TOWN GREEN STAGE
IFB No. 100812-FY16-18
Addendum #3
February 24, 2016

Questions & Answers:

Attachment A

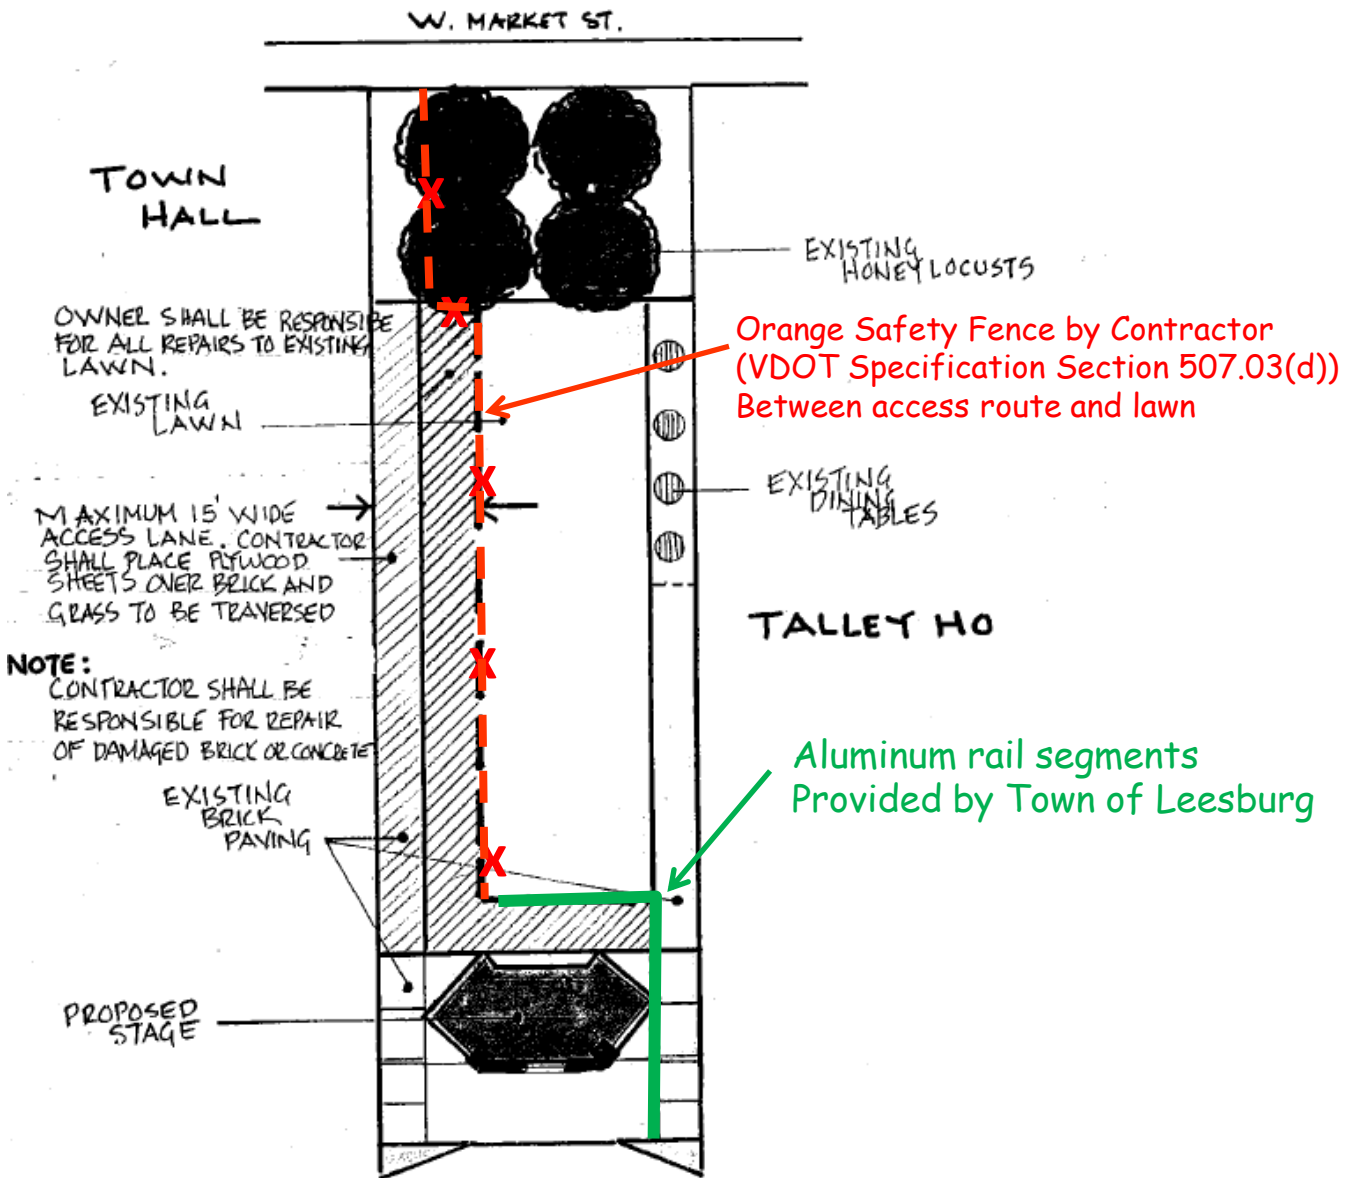
Question 1: Who is responsible for protecting and restoring the existing lawn that will be trafficked over in order to provide access to the work area?

Question 2: Is there a requirement for temporary fencing? If so where is it to be located?

Answer 1: The contractor shall limit the access between the site to the west side of the Town Green as shown on the attached sketch (Attachment A). The contractor will be allowed to use the existing brick sidewalk and adjacent grass area for this access. The contractor shall protect the sidewalk and grass area with plywood or other approved method.

The contractor is responsible for restoring the lawn if it is damaged by the construction.

Answer 2: The contractor shall provide temporary safety fencing to separate the access route between West Market Street and the project site from the remainder of the Town Green as shown on the attached sketch (Attachment A). The Town will provide metal rail fencing panels to be used by the contractor to separate the construction site from the Town Green.
